Object	<b>FMC nanoFIP PCB design review in TE-EPC-CCE</b>
Purpose	To check SCH and PCB of the FMC nanoFIP and the compatibility with EPC controllers.
Executer(s)	Slawosz Uznanski
Date	2017-06-21 / CERN, 774-1-079
Requester	Maciej Suminski

Power ON Reset

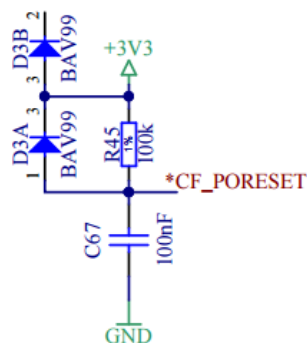
- 2/7:
  - What is the clock oscillator reference? The IQD FREQUENCY PRODUCTS LF SPX0018042 clock oscillator meets the specification and can be used. Please reference to the [4]. The radiation report can be found in in the [5].
  - Power\_ON rest add BAV99 for faster transient removal:
